DISD - W.W. BUSHMAN REPLACEMENT ELEMENTARY SCHOOL

ZONING CASE # Z 212-271

01 SITE PLAN
 1" = 50'-0"

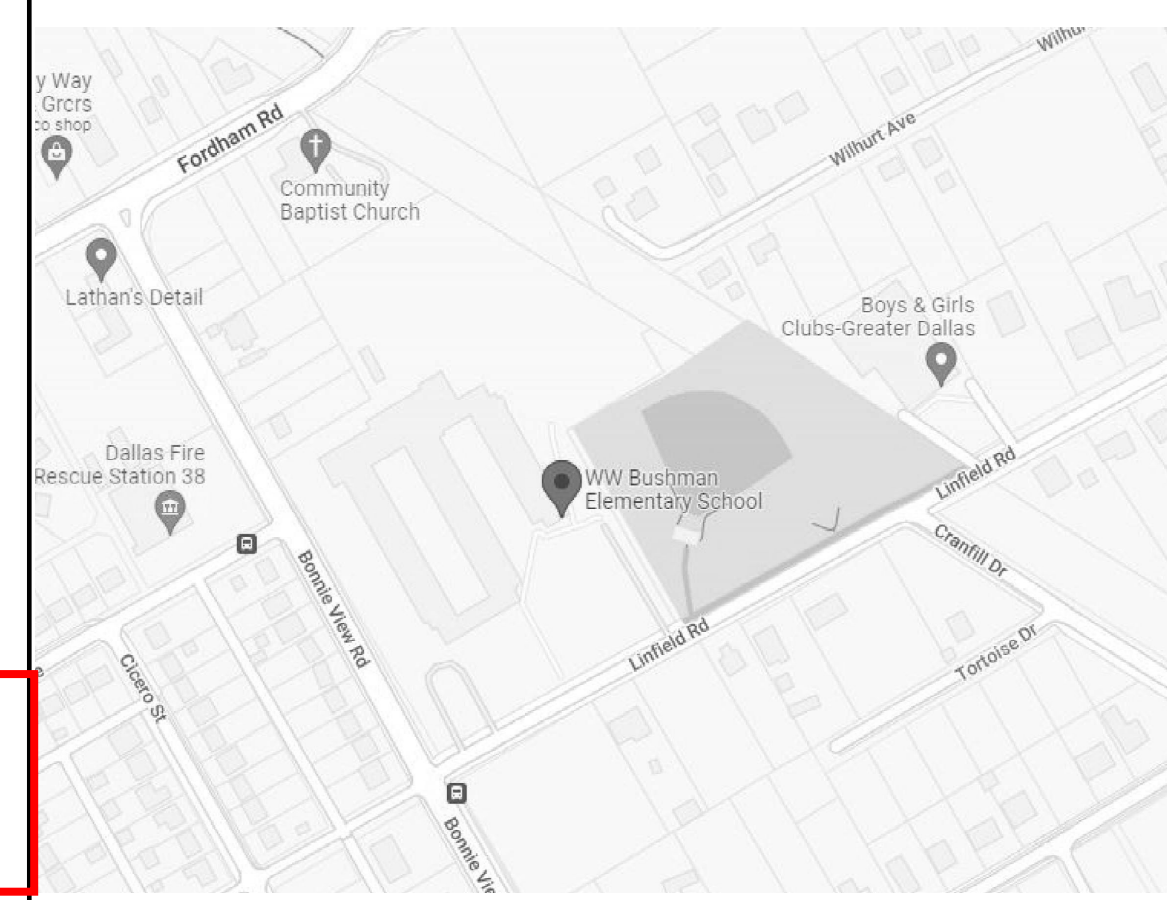
- 1. RESOLVED
- 2. RESOLVED
- 3. NOTE: 5'-0" WIDE SIDEWALK IS MINIMUM REQUIRED FOR ADA COMPLIANCE; HOWEVER, STAFF RECOMMENDS MINIMUM 6'-0" WIDE SIDEWALKS AT SCHOOLS.
- 4. OTHER PEDESTRIAN AMENITIES SUCH AS BENCHES, TRASH CANS, AND PEDESTRIAN SCALE LIGHTING ARE RECOMMENDED AT REGULAR INTERVALS ALONG STREET FRONTAGES, HOWEVER, THESE ITEMS ARE NOT CURRENTLY REQUIRED BY CODE.

⊕ LIGHT POLE
 ⊕ 6'-0" HIGH PLAZA LIGHTS
 NOTE: MINIMUM 6'-0" WIDE SIDEWALK W/ MINIMUM 5'-0" WIDE BUFFER PROVIDED ALONG THE ENTIRE LENGTH OF ALL STREET FRONTAGES, TYP.

Staff comment:
 NOTE: CONSIDER ADDING SIDEWALK LANGUAGE AS AN SUP CONDITION TO COMMUNICATE INTENT THAT SIDEWALKS AND BUFFER ARE TO BE PROVIDED AS NOTED ABOVE (i.e. TO ELIMINATE THE POSSIBILITY OF A SIDEWALK WAIVER BEING OBTAINED FOR THE PROPERTY).

Staff comment:
 TABLE HAS INCORRECT DATA. CONFIRM THE MATH AND CORRECT THE DATA.

Staff recommended language:
 MINIMUM 6'-0" WIDE SIDEWALK w/ MINIMUM 5'-0" WIDE BUFFER MUST BE PROVIDED ALONG THE ENTIRE LENGTH OF ALL STREET FRONTAGES, TYP.
